Power Equipment

CODE NO: CC-270

SUBJECT: LOW VOLTAGE LIGHT IMPROPERLY WIRED ON 2135 SERIES TRACTORS, SERIAL NUMBERS 239301 TO 240610.

Fig. 1

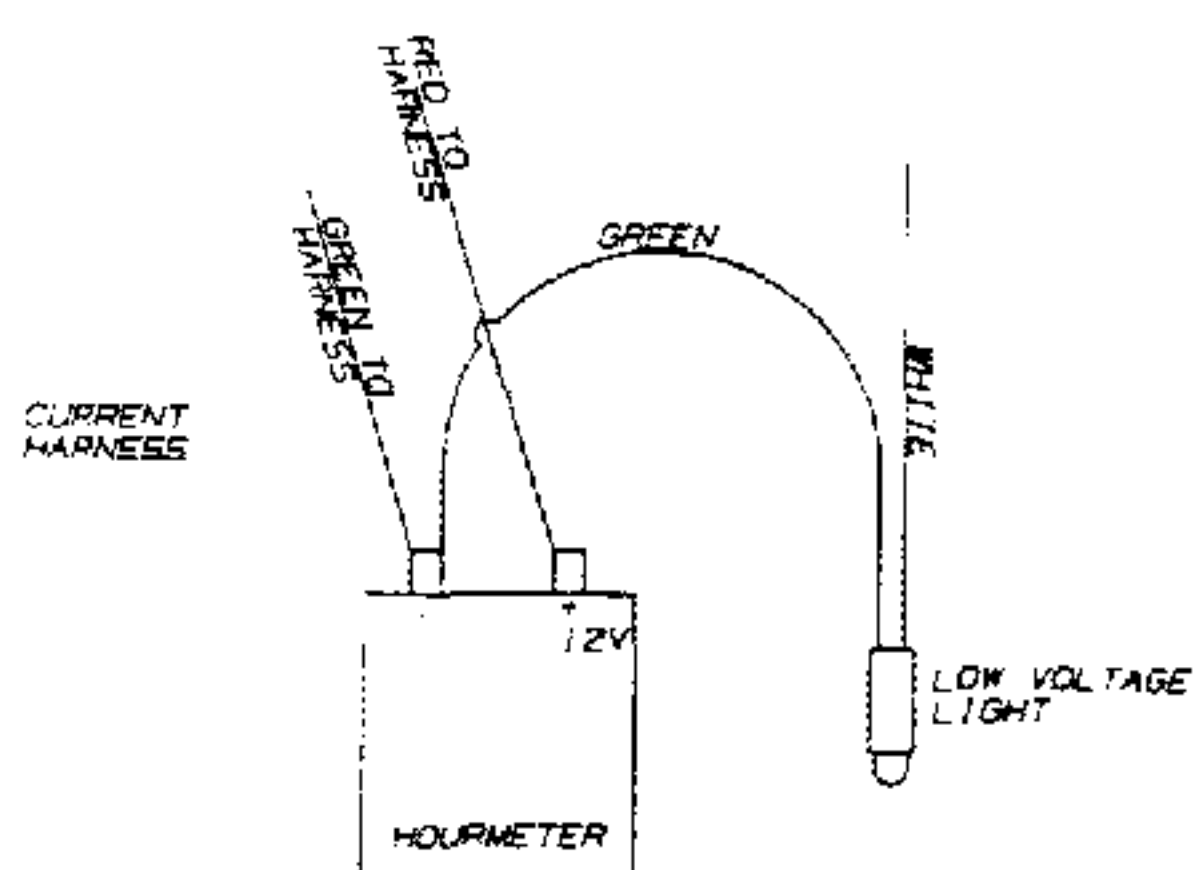
The low voltage light on the above serial numbered tractors have been improperly wired. It is currently wired as shown in figure 1. See below. As it is wired now the bulb will never illuminate should the battery become discharged.

- 1) Snip the green wire that runs from the low voltage light to the negative side of the hour meter, as close to the hour meter as possible. (See Fig. 1)
- 2) Pull the red wire loose from the positive side of the hour meter and remove the insulator block that covers the terminal end.
- 3) Snip the terminal end from the red wire and strip back the insulation approximately 1/4 inch. Do the same with the green wire you previously snipped from the negative side of the of the hour meter.
- 4) Connect the red and green wires together into one new terminal end and securely clamp together with wire harness pliers. (See fig. 2).
- 5) Reinstall the terminal insulator on the terminal end and reconnect to the positive side of the hour meter.
